The LLTNP, outdoor recreation and the 'Master Plan' for Tarbet.

Tarbet Visitor Site Masterplan
for Loch Lomond & The Trossachs
National Park Authority
December 2022

•??The locked gate and road leading to the slipway•

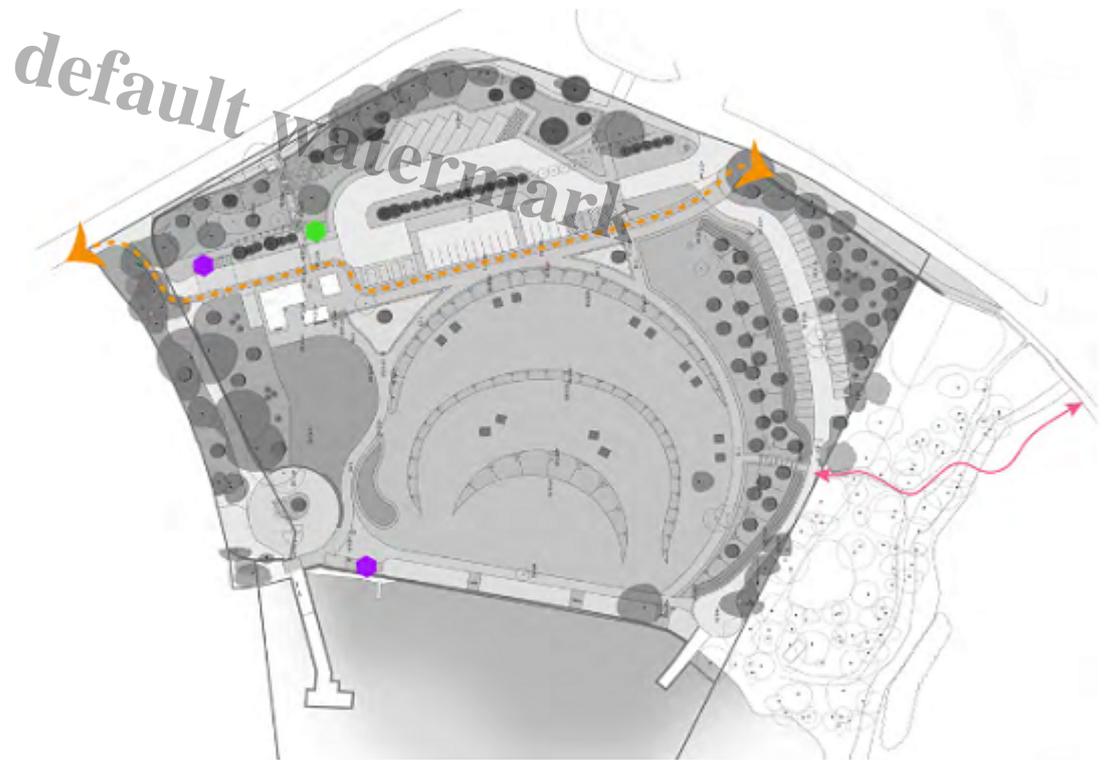
Currently canoes/kayaks have to be carried down a track past a gate locked by the Park Authority to a small beach by the northern pier. Cars are parked just above the gate.

A far better solution is to extend the beach area and open up the track to allow loading/unloading alongside the extended beach. Parking should be in a reserved area at its current position. This would fit in with ORP Action 32.

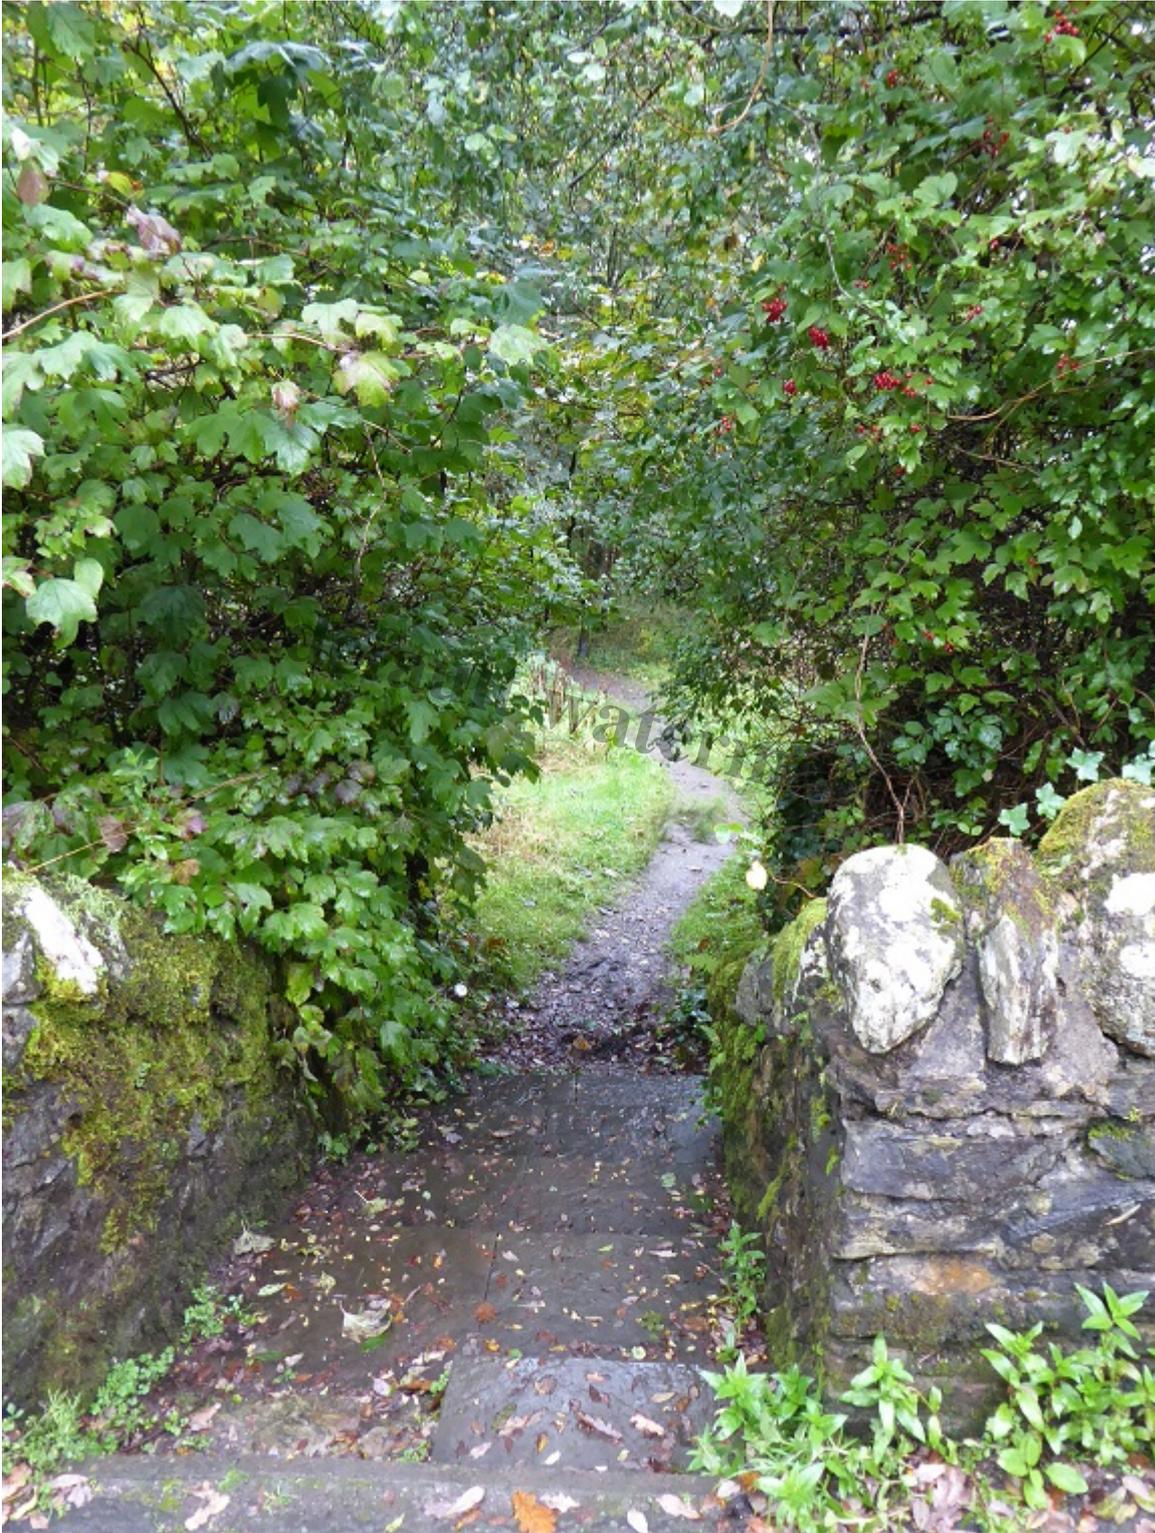
1. The kayak launch site at the north end of Inveruglas Car Park has been assumed by at least one individual as "reserved for campervans" rather than as an access point for kayaks on the Loch
2. The main beach at Firkin Point in the permit area was at one time, occupied by a large family frame tent
3. A group of teenage Spanish Scouts travelling south could find nowhere to camp.
4. As many as 30 Campervans have occupied the Tarbet parking area one evening.

The reservation of a section of the car park in the masterplan for 4 Campervans is both inappropriate and inadequate and the decision to locate the much needed waste disposal facility at the Tarbet car park now appears a mistake.

The Park Authority should be looking to set up a minimum facility site for at least 20 vans and 20 family tents nearby. A suggested location is close to the station. Campervans should be encouraged not to overnight in lay-bys etc where there are no waste disposal facilities.
